service bulletin

No. 98-1

Siphon Break – Sport Jet

Sport Jet 175XR² – Serial number **0E288000** thru **0E341671**

- a** - Clamp for Siphon Break
- b** - Siphon Break
- c** - Screen End which Lays in Bilge

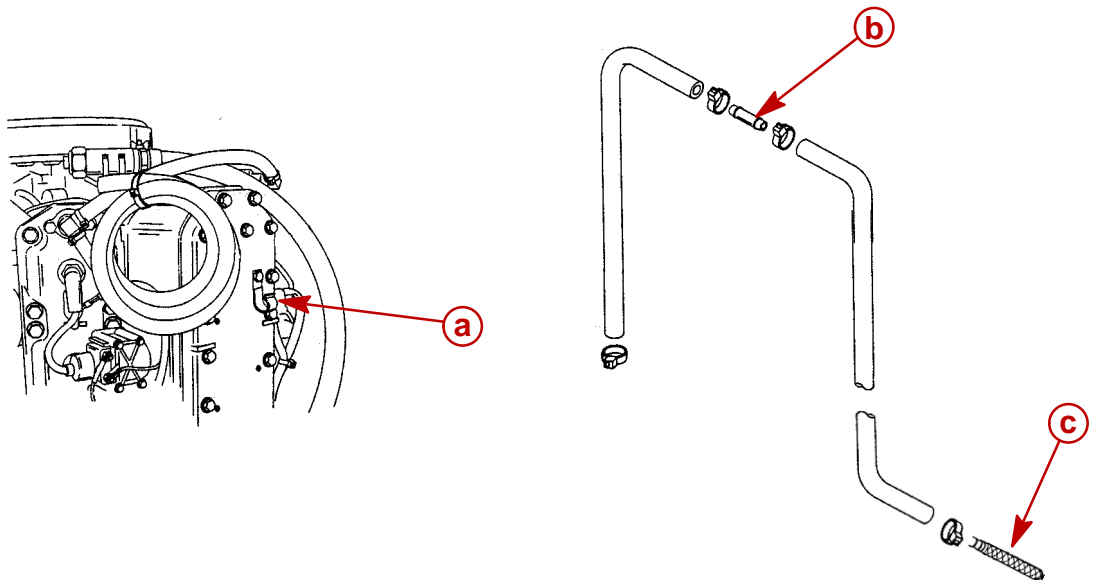
It has recently come to our attention that the hole in the siphon break may be “flashed over” (not open). This condition may allow water to siphon back into the boat after the engine is turned off. Water siphoning back into the boat can only occur when water is being drawn out through the siphon system at the time the engine is turned off.

Siphon break and hose assembly are secured to the exhaust manifold with an open end clamp. Remove assembly from the clamp. Cut the cable ties securing both hoses to the siphon break. Replace siphon break with new part and secure siphon break to hoses using new cable ties. Reinstall siphon break assembly to clamp on exhaust manifold.

Order : Qty. 1 of 826702 Siphon Break
 Qty. 2 of 816311 Cable Tie
